ADDENDUM NO. 3

Date: September 7, 2018
Project: **Secondary Treatment Plant Upgrade & Recycled Water Expansion**
Job No.: 12600-07/16650-02

The following changes and/or clarifications are hereby made to the Contract Documents, and shall become a part of the Contract Documents dated July 2018.

**SECONDARY TREATMENT PLANT UPGRADE
 AND RECYCLED WATER EXPANSION**
INSTRUMENTATION - P&IDS
PRIMARY CLARIFIER 1

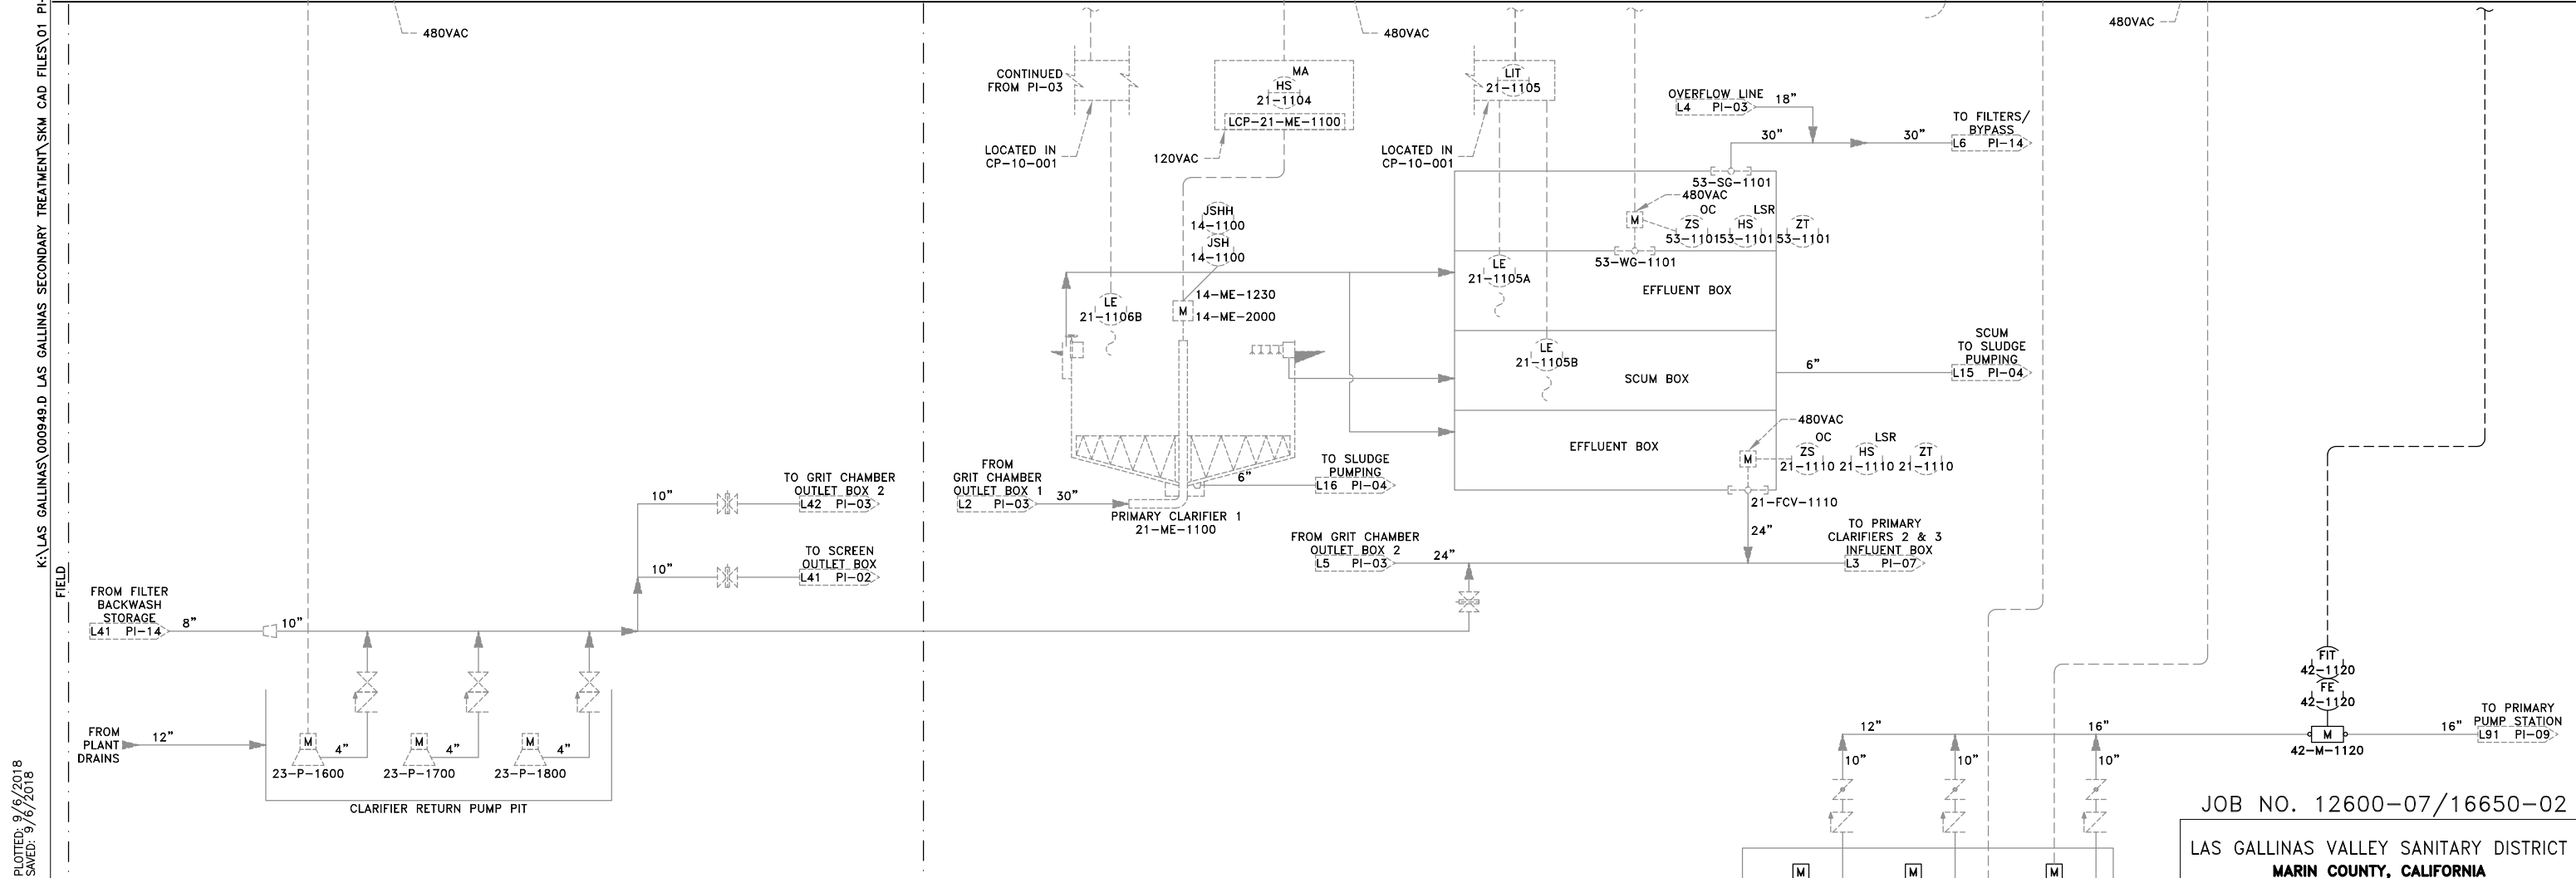
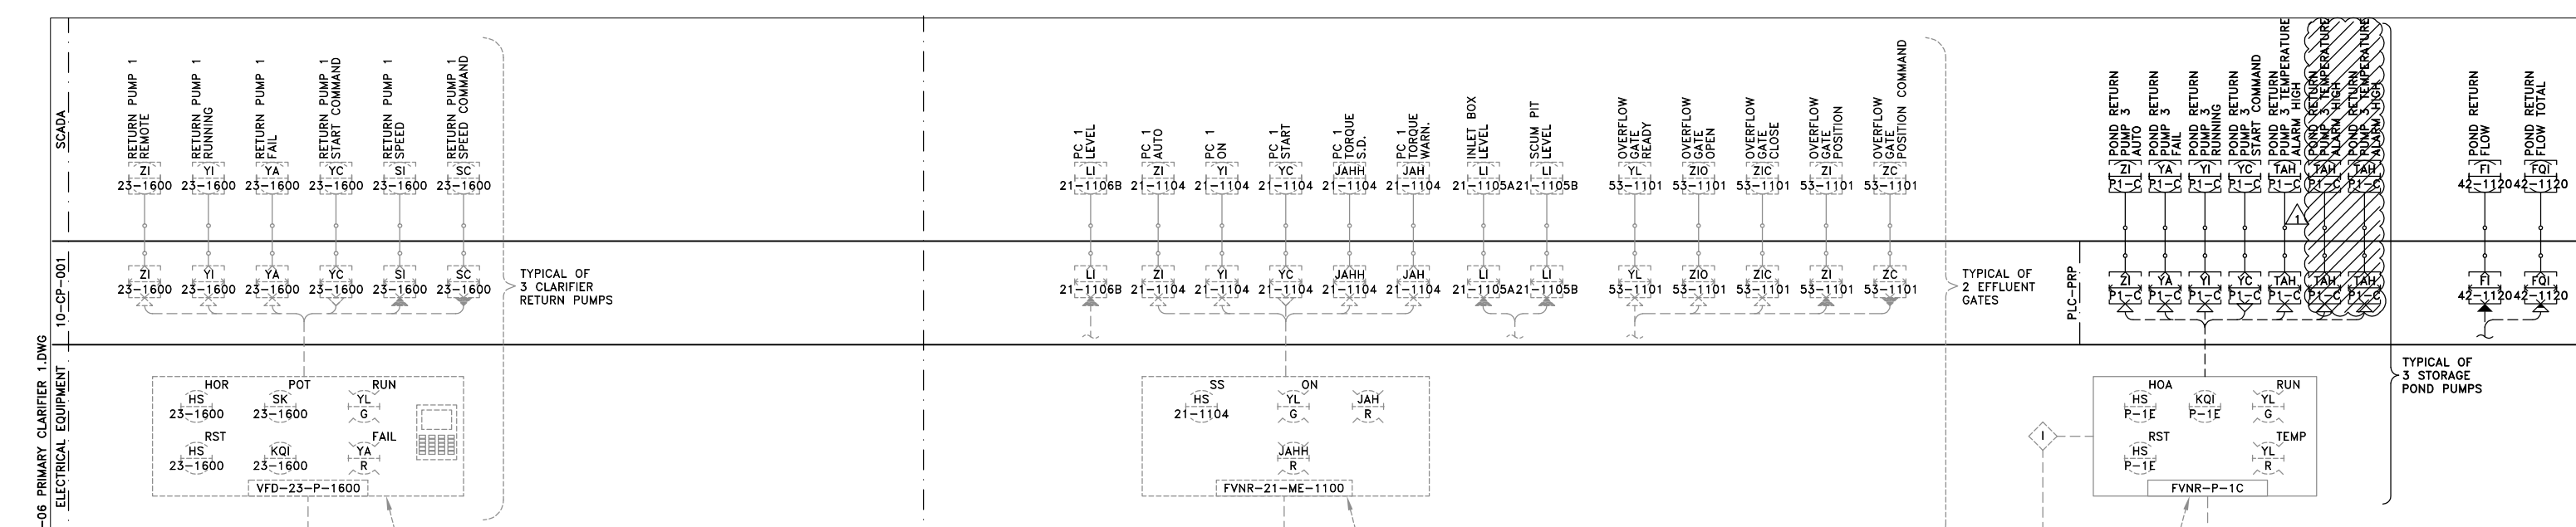
1. **Sheet PI-06:** IO has been updated for the Pond Storage Pumps. **Refer to re-issued sheet for details.**
2. **Sheet PI-09:** IO has been updated for Primary PS level floats, which were shown as analog inputs. They have been updated to be shown as discrete inputs. IO for Primary Pump Station pumps has been updated to show the check valve position as hardwired as well as all bypass contactor IO. **Refer to re-issued sheet for details.**

**ELECTRICAL - SITE
 SITE PLAN 5**

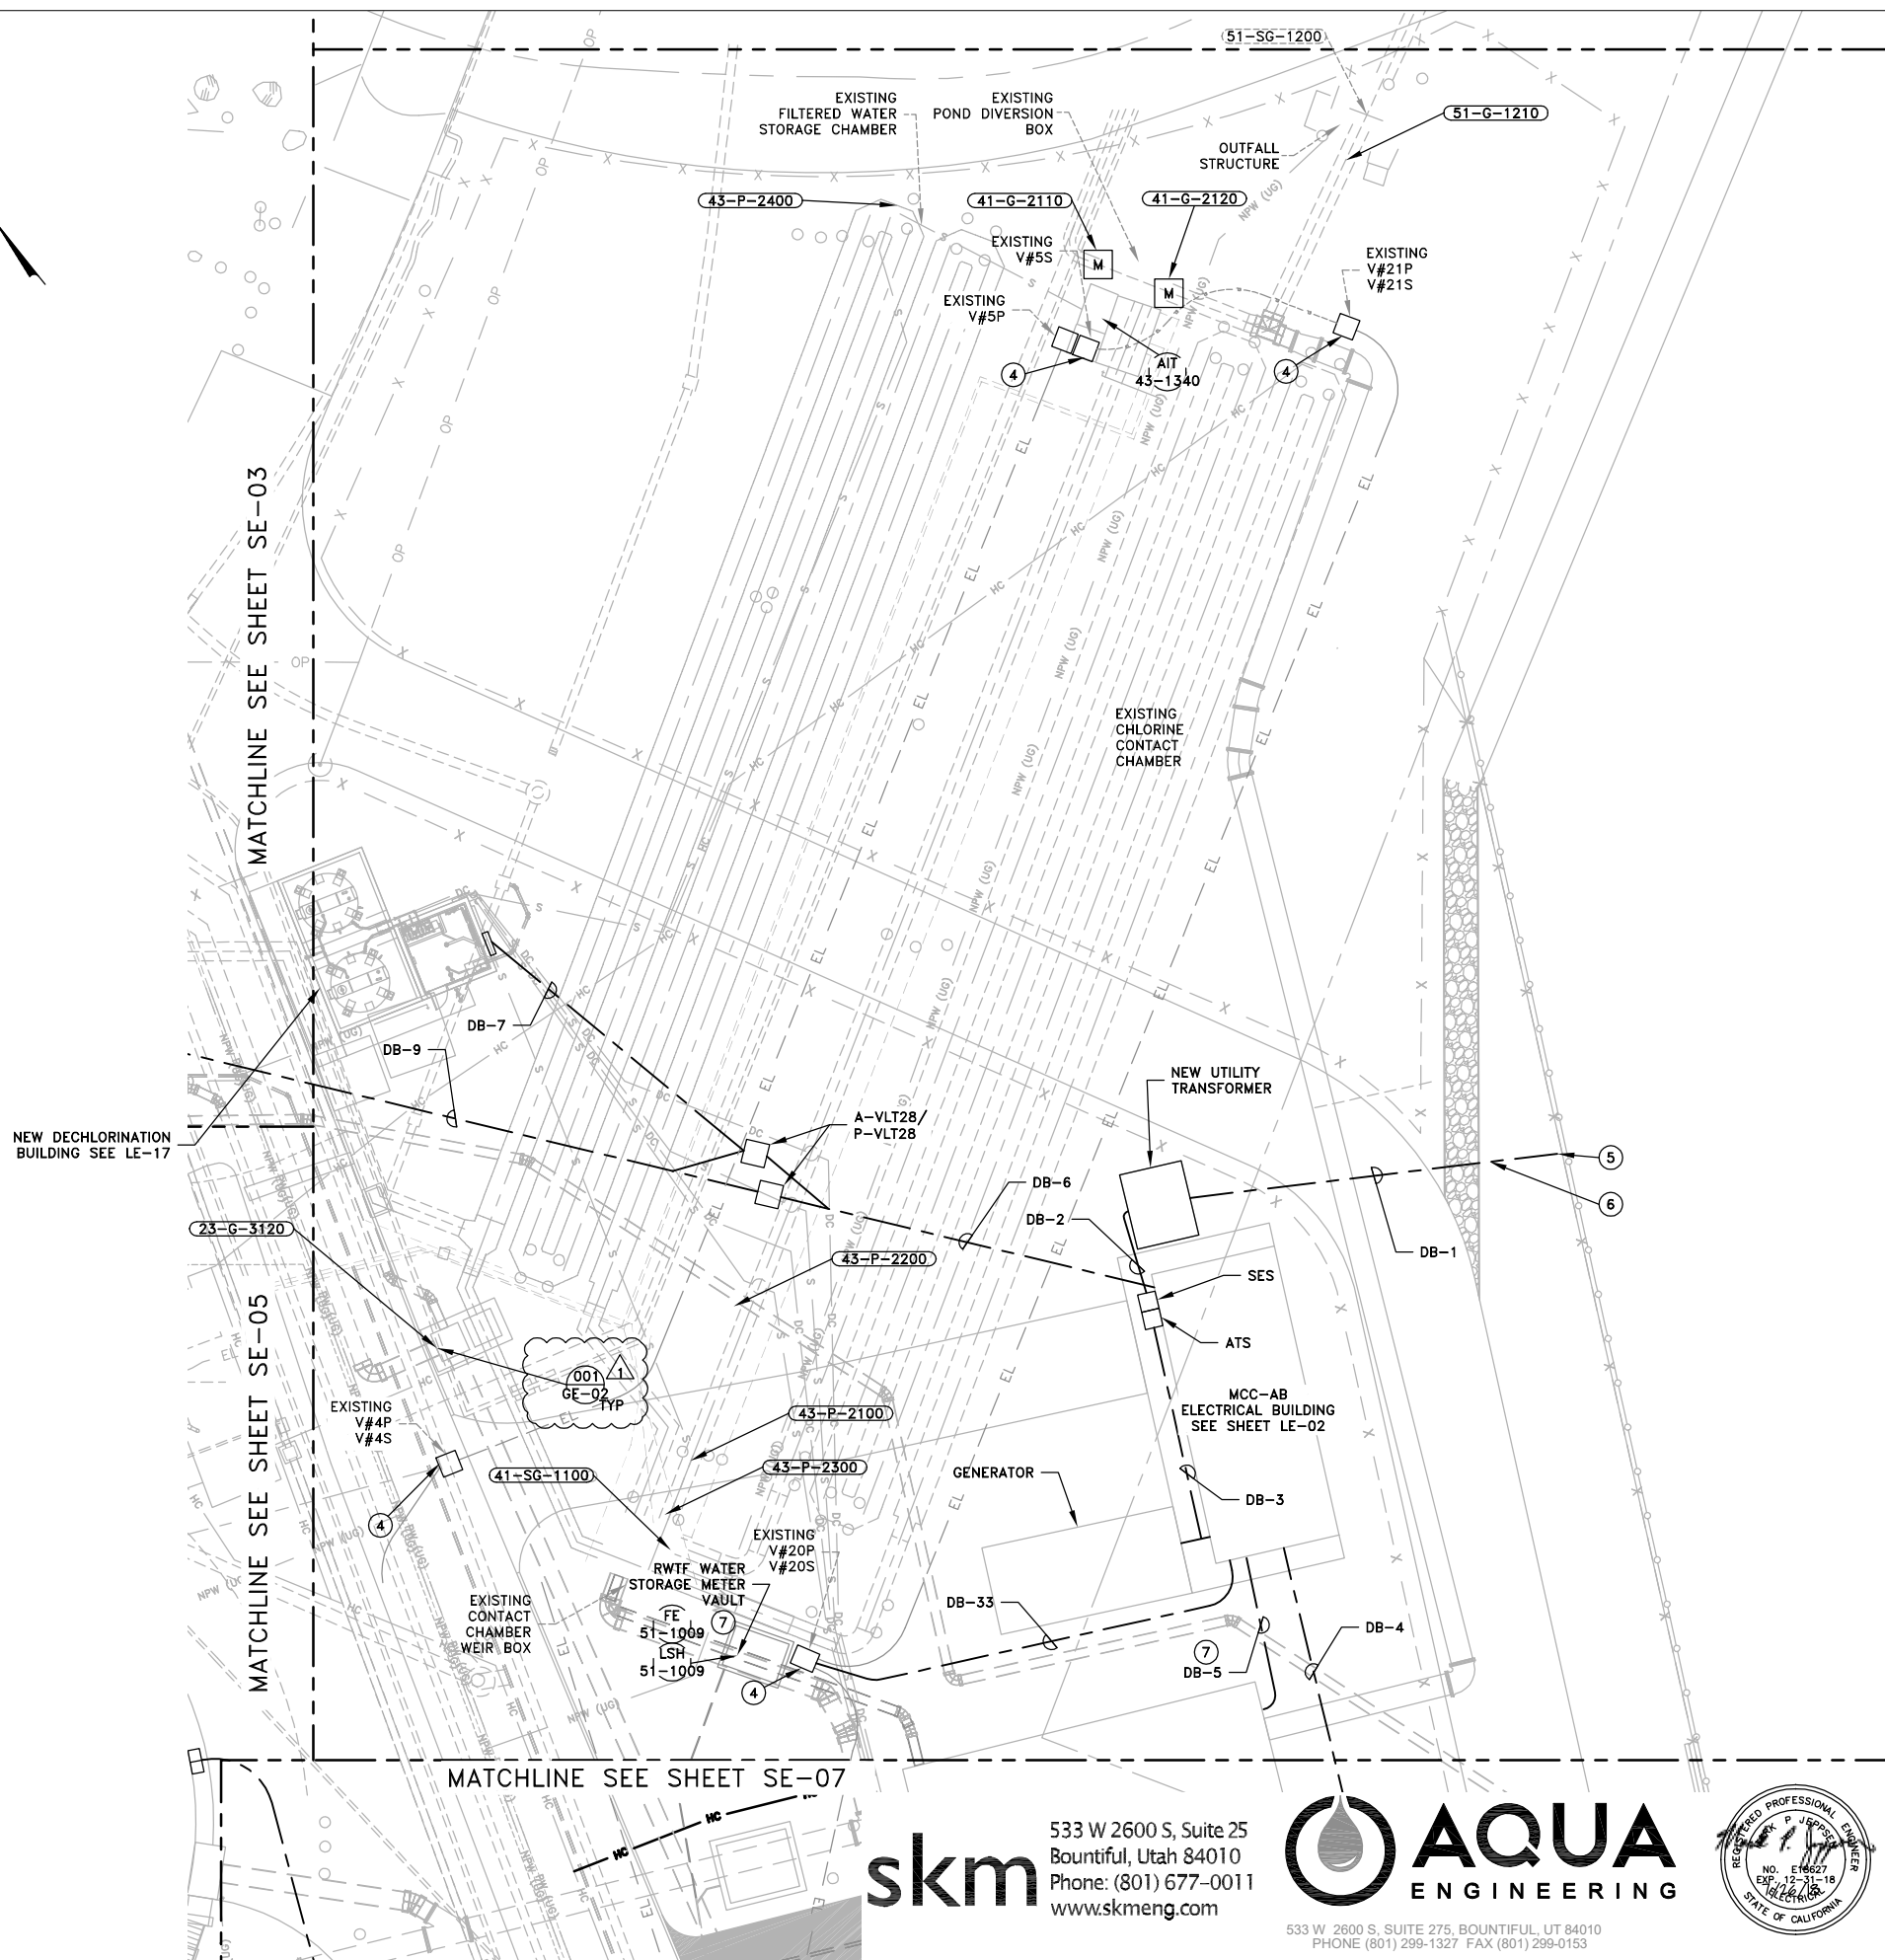
5. **Sheet SE-03:** Remove sheet notes number 4 and 5.
6. **Sheet SE-06:** Detail callout for mounting disconnect added. **Refer to re-issued sheet for details.**

**RECYCLED WATER
 DISTRIBUTION
 PUMP STATION PLAN**

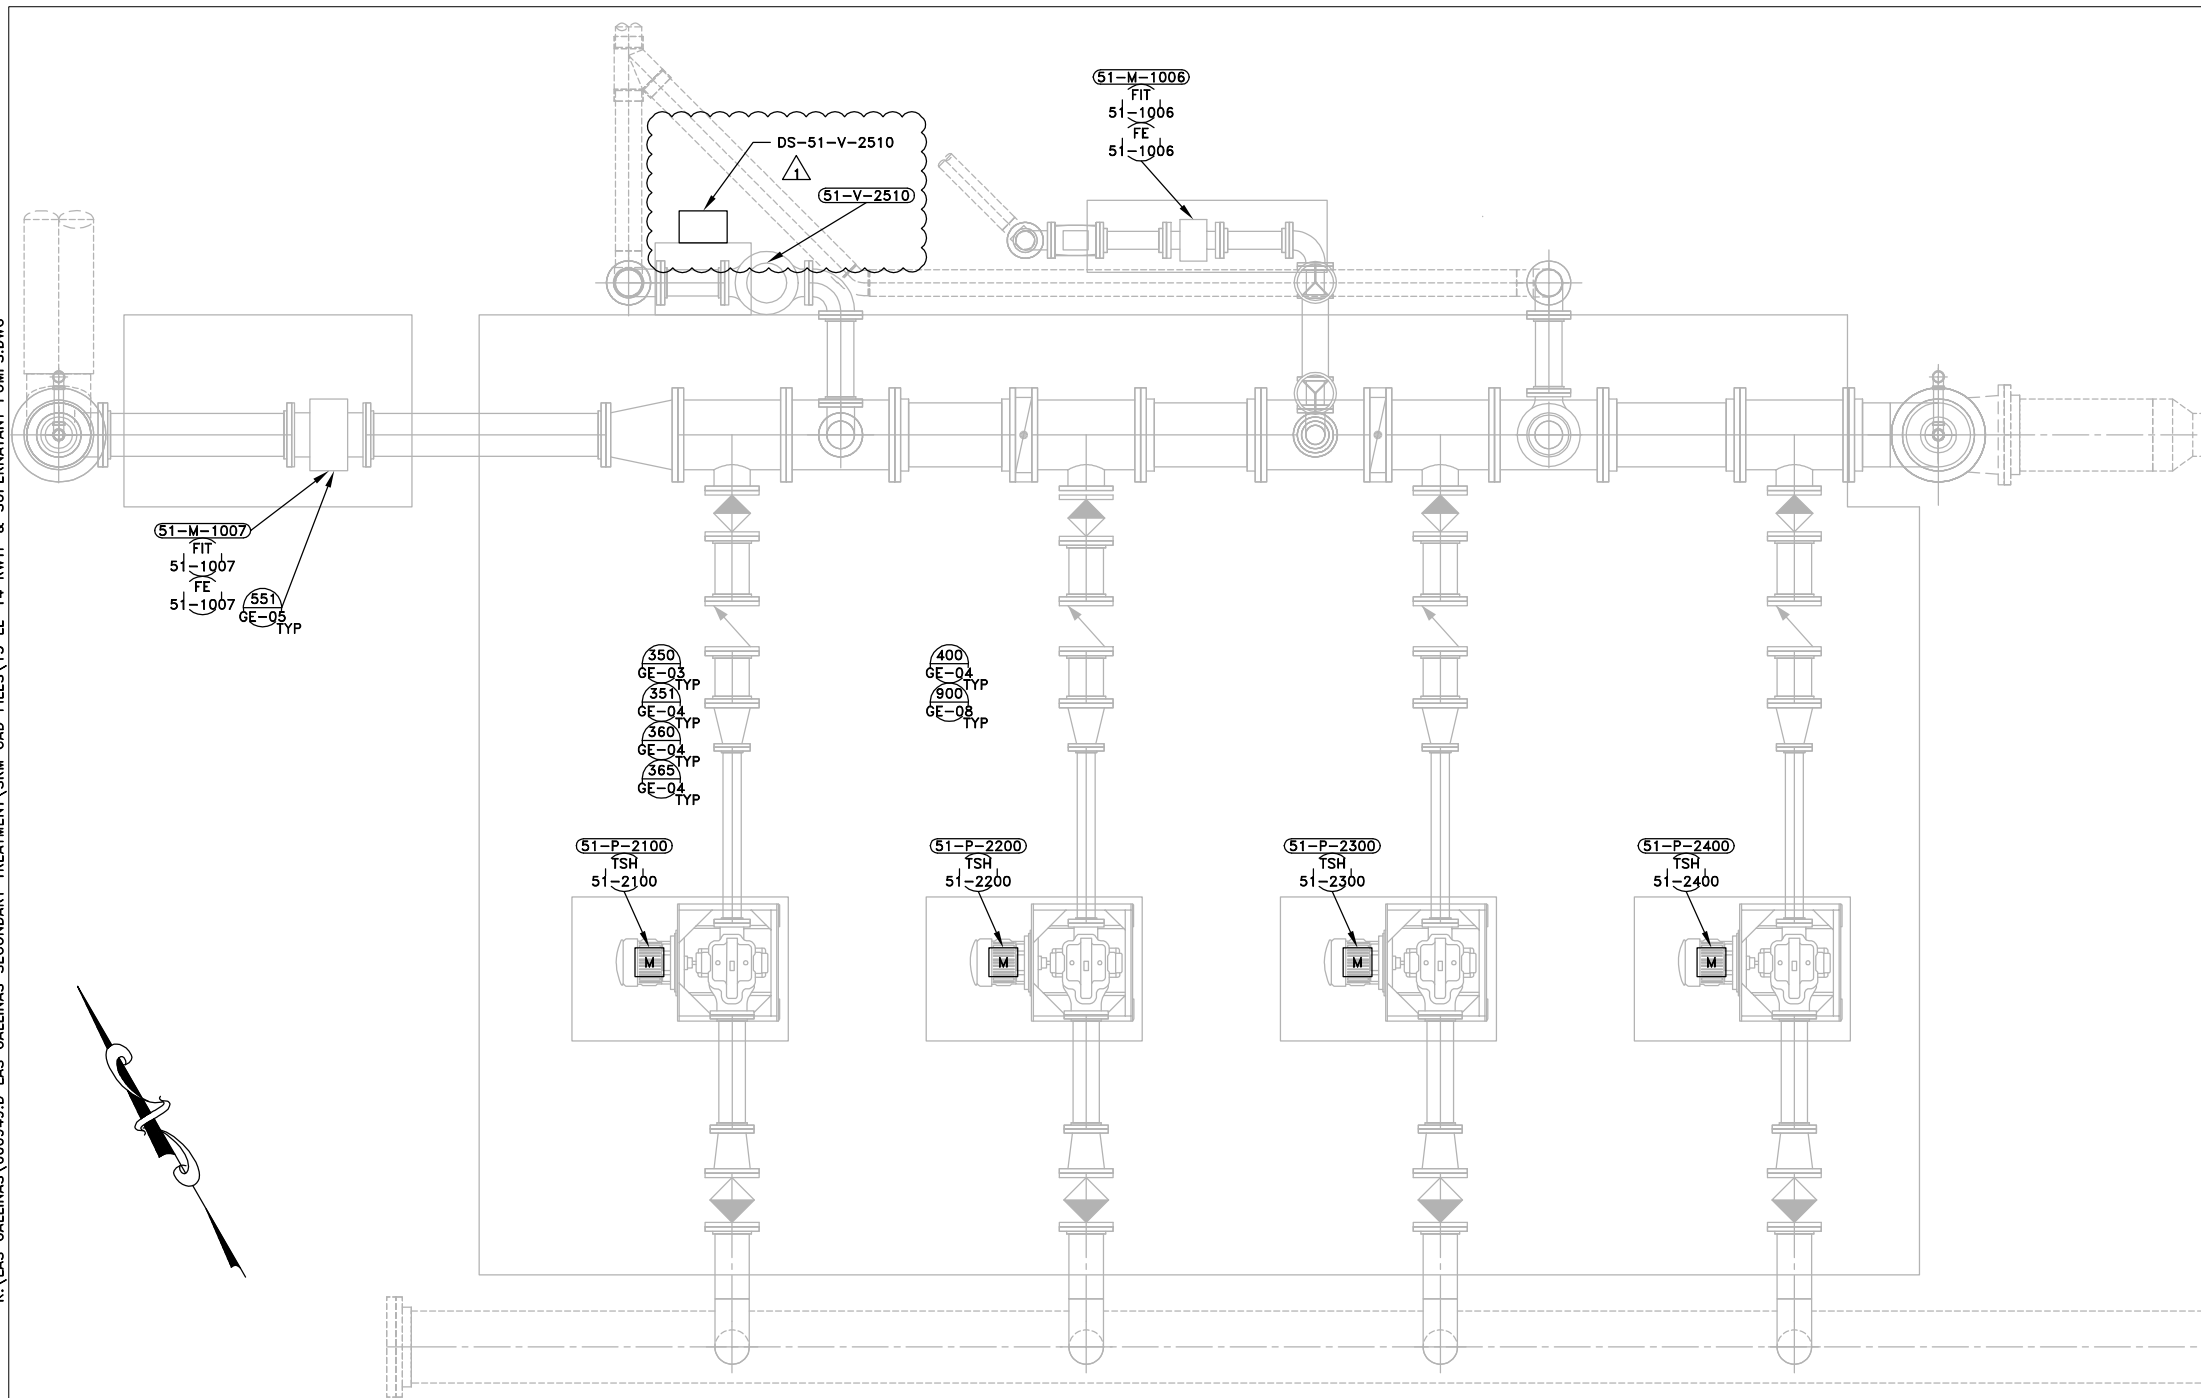
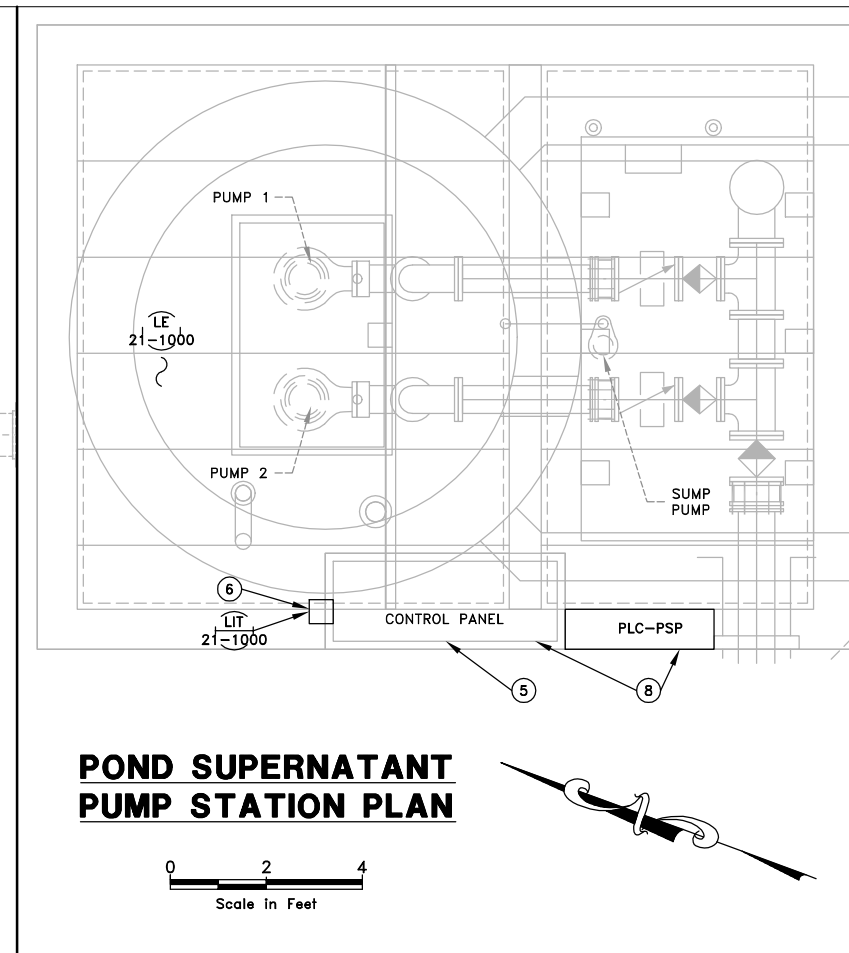
7. **Sheet LE-14:** Added locations of DS-51-V-2510, 51-V-2510, and LP-RWDP. **Refer to re-issued sheet for details.**
8. **Sheet LE-16:** The callout for LP-UV has been changed to LP-UV-2. The reference to E-18 on note 13 should reference drawing E-19.
